**OFFICER'S REPORT FOR:**

**Proposed Waimakariri District Plan: Ranga waka - Transport (TRAN)  
Proposed Waimakariri District Plan: Transport**

**Andrew MacLennan – Consultant Planner**

**21 July 2023**

Figure 1: Approach Sight Triangles for Level Crossings with “Stop” or “Give Way” Signs

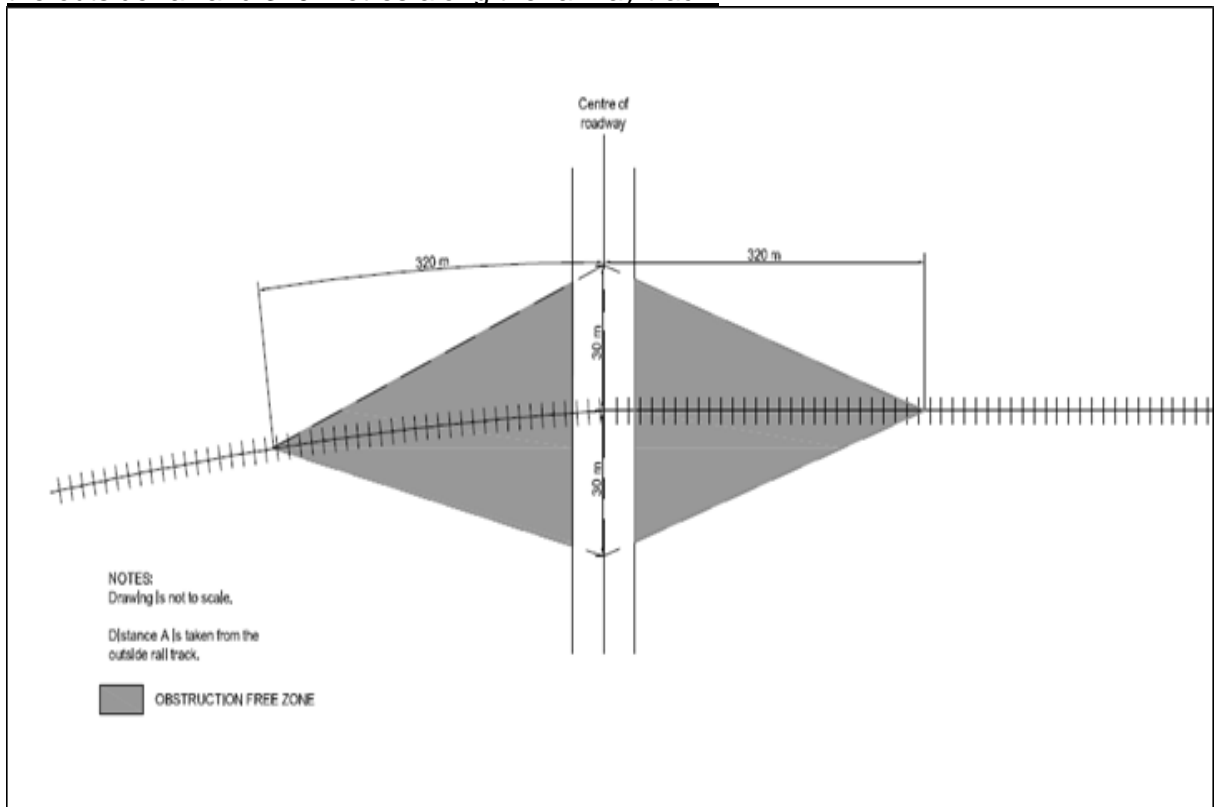
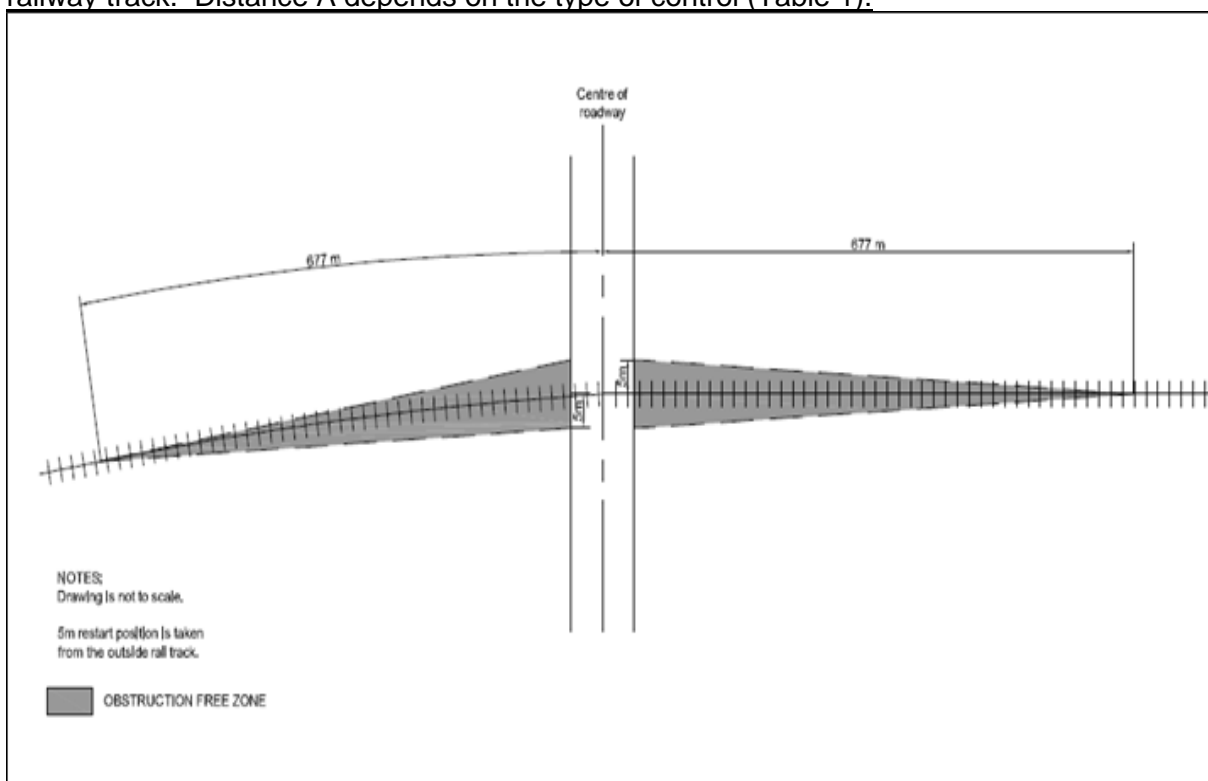
##### **Approach sight triangles at level crossings with Stop or Give Way signs** <sup>85 86</sup>

On sites adjacent to rail level crossings controlled by Stop or Give Way Signs, no building, structure, road intersections, vehicle crossings or vegetation shall be located within the shaded areas shown in Figure 1. These are defined by a sight triangle taken 30 metres from the outside rail and 320 metres along the railway track.

On sites adjacent to all rail level crossings, no building, structure, road intersections, vehicle crossings or vegetation shall be located within the shaded areas shown in Figure 2. These are defined by a sight triangle taken 5 metres from the outside rail and distance A along the railway track. Distance A depends on the type of control (Table 1).

1. Figures 1 and 2 show a single set of rail tracks only. For each additional set of tracks add 25 m to the along-track distance in Figure 1, and 50 m to the along-track distance in Figure 2.
2. All figures are based on the sighting distance formula used in NZTA Traffic Control Devices Manual, Part 9 Level Crossings. The formulae in this document are performance based; however the rule contains fixed parameters to enable easy application of the standard. Approach and restart distances are derived from a:
  - train speed of 110 km/h
  - vehicle approach speed of 20 km/h
  - fall of 8 % on the approach to the level crossing and a rise of 8 % at the level crossing
  - 25 m design truck length
  - 90° angle between road and rail

Figure 1: Approach Sight Triangles for Level Crossings with “Stop” or “Give Way” Signs

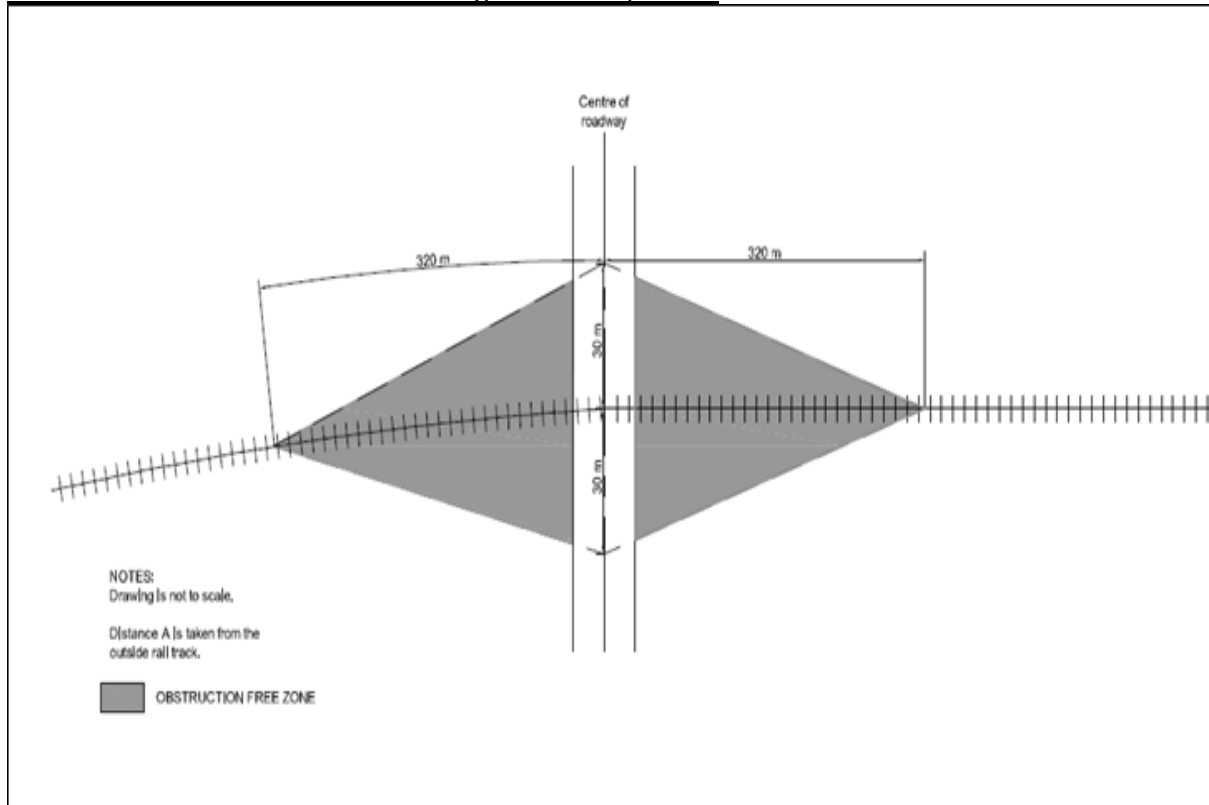
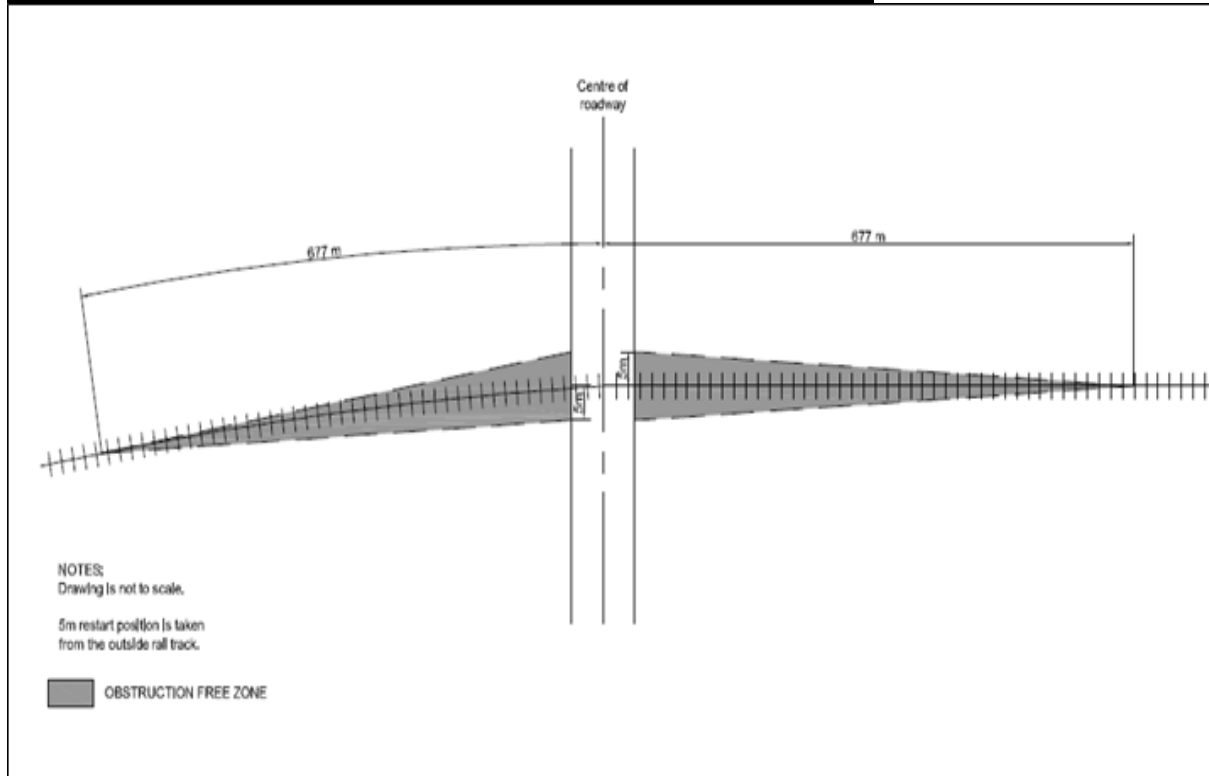
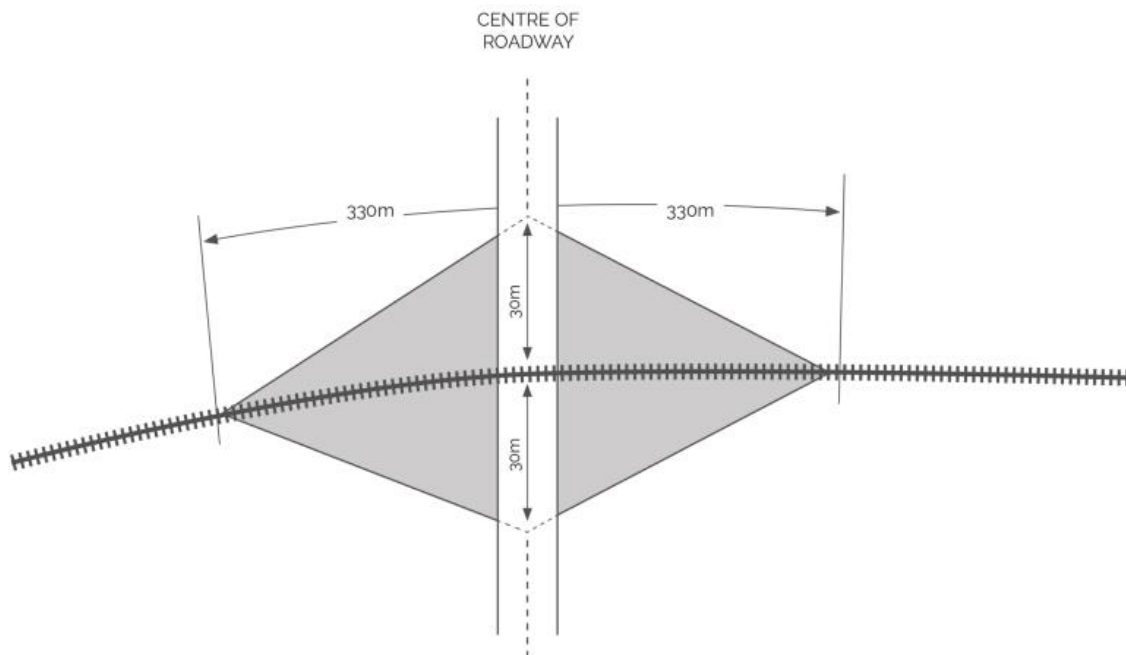
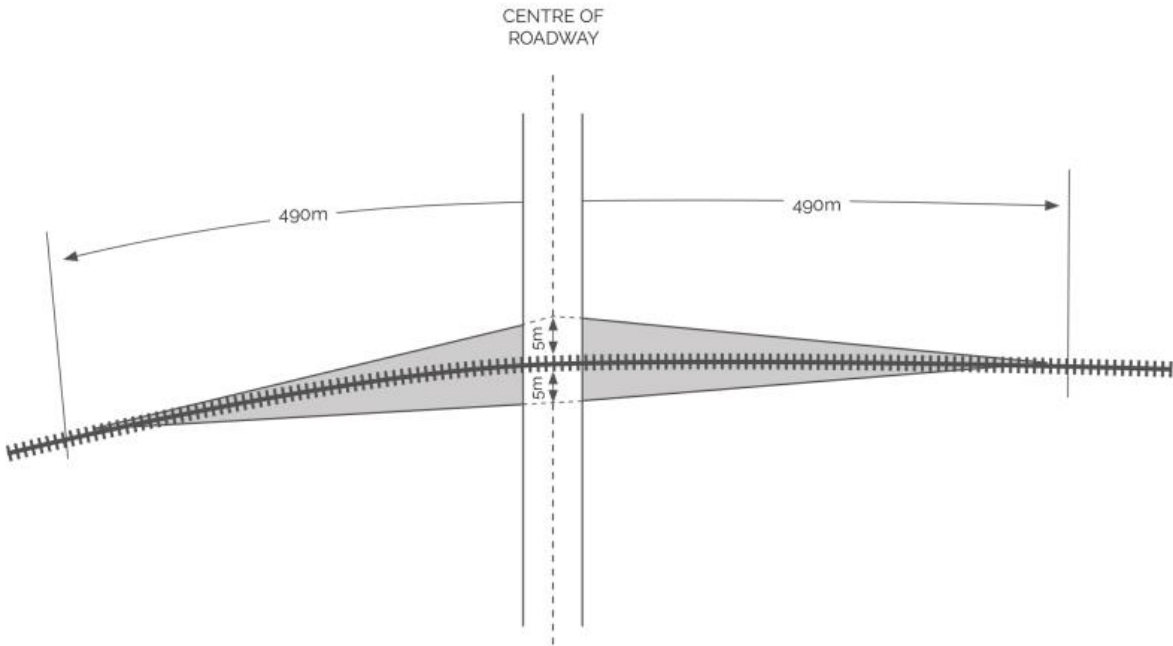
### Approach sight triangles at level crossings with Stop or Give Way signs <sup>188 189</sup>

On sites adjacent to rail level crossings controlled by Stop or Give Way Signs, no building, structure, road intersections, vehicle crossings or vegetation shall be located within the shaded areas shown in Figure 1. These are defined by a sight triangle taken 30 metres from the outside rail and 320 metres along the railway track.

On sites adjacent to all rail level crossings, no building, structure, road intersections, vehicle crossings or vegetation shall be located within the shaded areas shown in Figure 2. These are defined by a sight triangle taken 5 metres from the outside rail and distance A along the railway track. Distance A depends on the type of control (Table 1).

Of particular concern are developments that include shelter belts, tree planting, or a series of building extensions. These conditions apply irrespective of whether any visual obstructions already exist.

- Figures 1 and 2 show a single set of rail tracks only. For each additional set of tracks add 25 m to the along-track distance in Figure 1, and 50 m to the along-track distance in Figure 2.
- All figures are based on the sighting distance formula used in NZTA Traffic Control Devices Manual, Part 9 Level Crossings. The formulae in this document are
